# **McDonald's Restaurant**

Re: Amended Site Plan Application ("Application") to the Town of Yorktown ("Town") Planning Board ("PB"), by McDonald's Corporation ("McDonald's") in connection with the redevelopment of the property located at 3481 Crompond Road / U.S. Route 202, Cortlandt, New York ("Property"), WCTM No.: Block 1, Lot 10, Map 36.05

**McDonald's Site Id. No. 031-0170**

RETROFITTED INLET FILTER  
 NOT TO SCALE

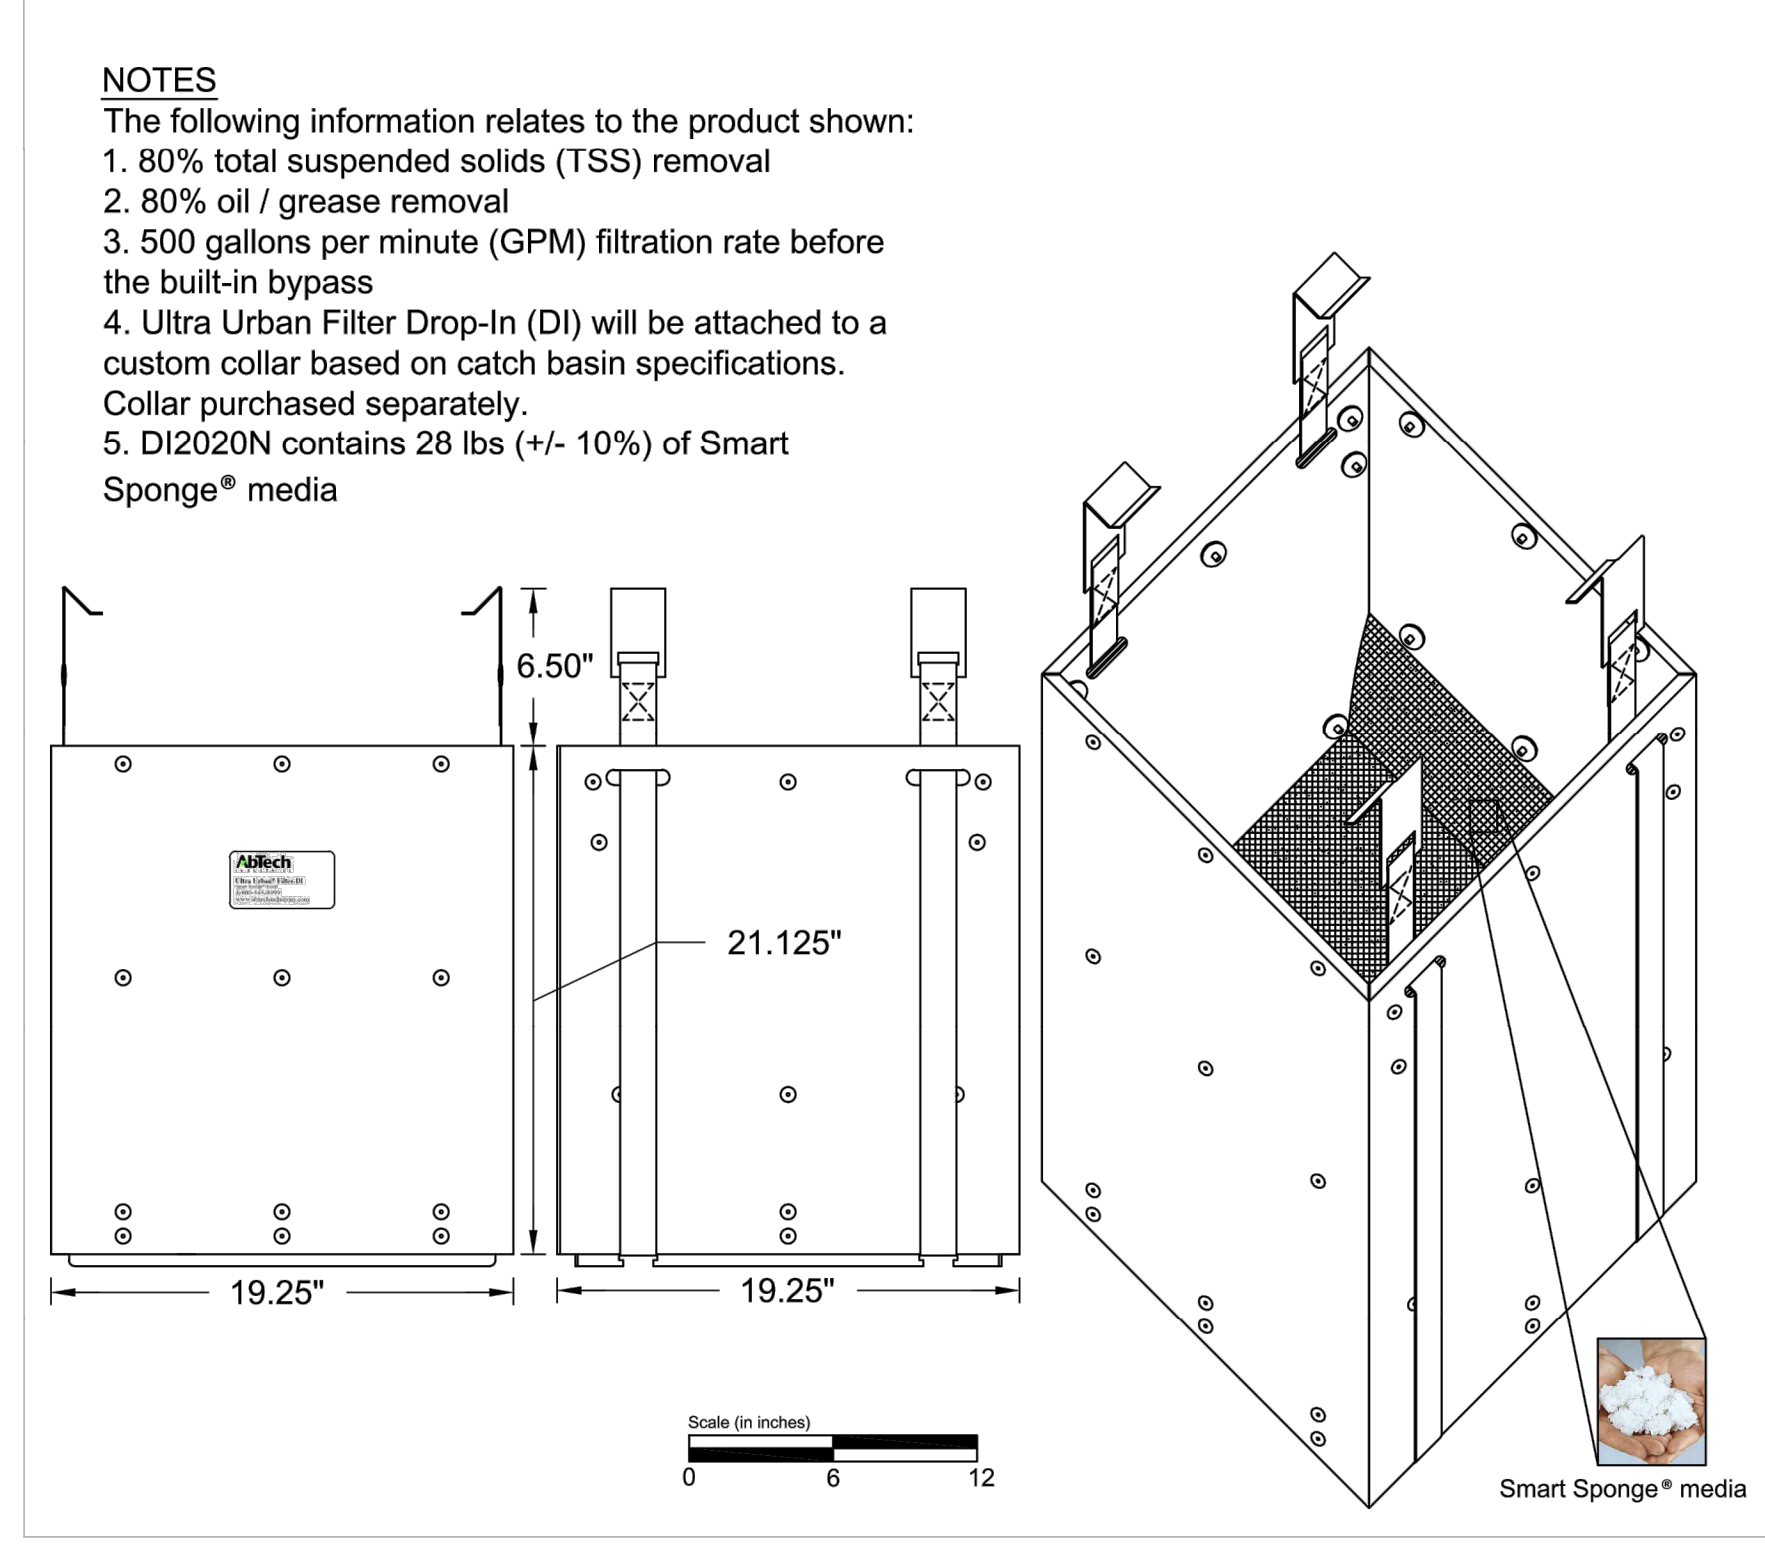
4. Include the detail for the proposed permanent inlet filter. Provide the sizing calculations for the proposed inlet filter. You may opt to do the sizing in Hydrocad or manually. Clarify the model number chosen for the filter.
5. Clarify that the 10& 100-year runoff will be bypassed away from the filter.
6. It is recommended that the Engineer may inspect the downstream pipe from the inlet filter to the discharge point prior to the start of construction to evaluate the condition of the pipe. This shall be added to the construction sequence as a contingency.
